TECHNICAL BULLETIN 2009-01

Date: 1st February 2009

Change in Fixing Method of Baffles

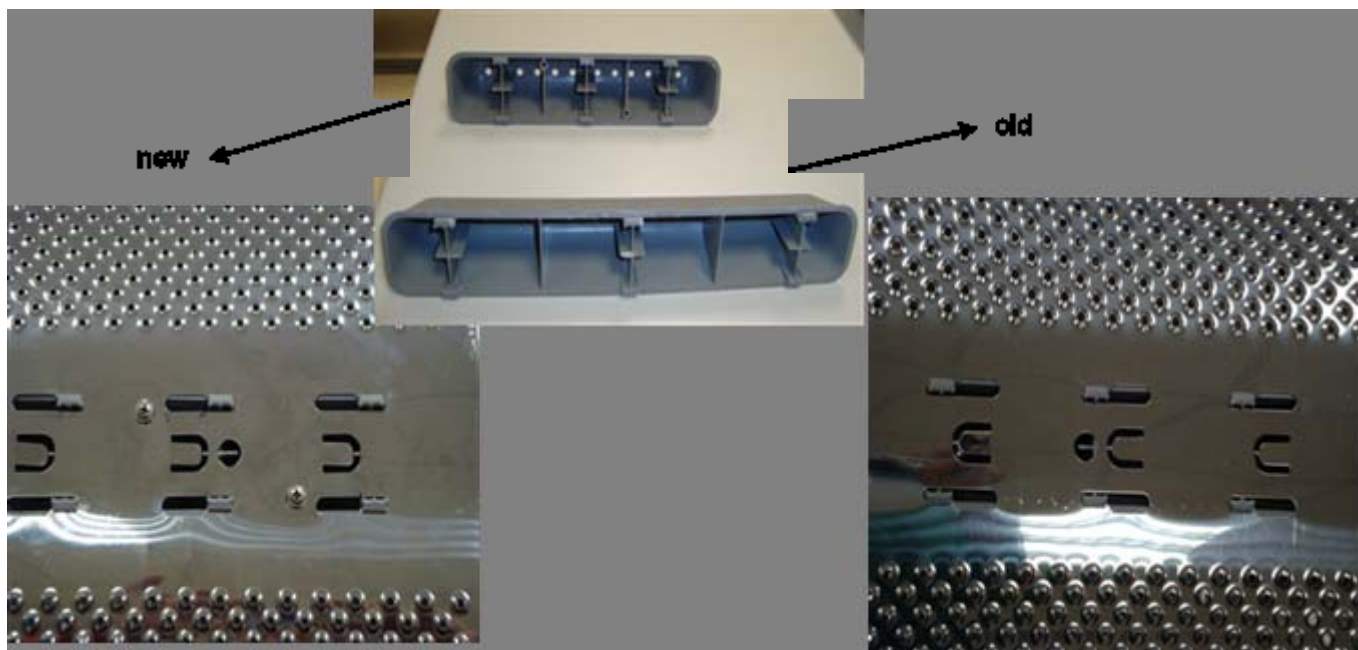
From February 2009 **all** washing machine baffles are to be fixed to the drum using 2 screws.

- **For the models with welded tubs:** The tub/drum assembly group will need to be changed.
- **For other tub types:** The baffles can be unscrewed and new baffles can be fixed after disassembling the tub.
- **For the large models:** The baffle used for the rest of the models is used also for these models. By this way all the baffles are unified.

For servicing products produced prior to this date the old baffle (28 1249 03 00) should be used.

New baffles can be used for servicing washing machines produced prior to this date
